Columbia River System (CRS) Fish Facility Design Review Work Group (FFDRWG)

USACE, Portland District (NWP) and Walla Walla District (NWW)

November 2024 Meeting Notes

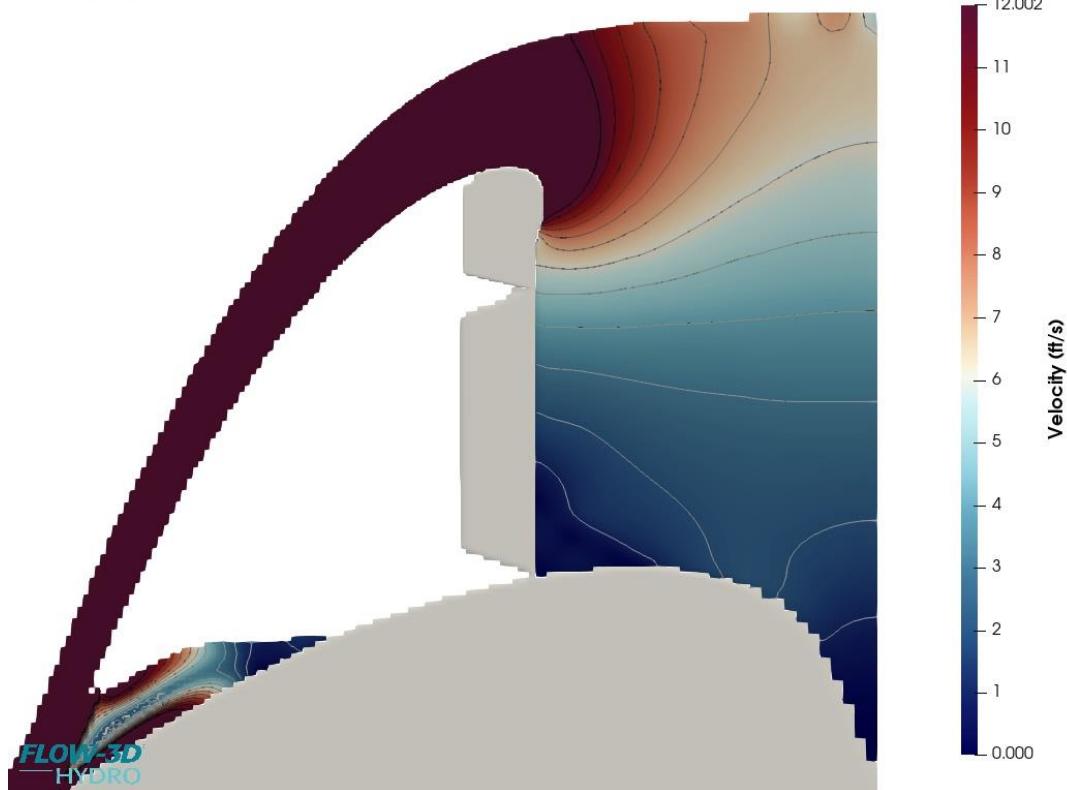
4.6.12.11 Chuck: Question for Ryan L. What is the water velocity at the rack's location?

4.6.12.12 Erick Van Dyke: Concerns for fish strikes, would be adding additional rack into the water.

4.6.12.13 Trevor: This wouldn't be as extreme as gate openings, but still a valid concern.

NWW Hydraulics is working on a more detailed velocity profile with the upstream slot location on the graph but it appears the velocity where the trash rack would go would be < 7 ft/sec.
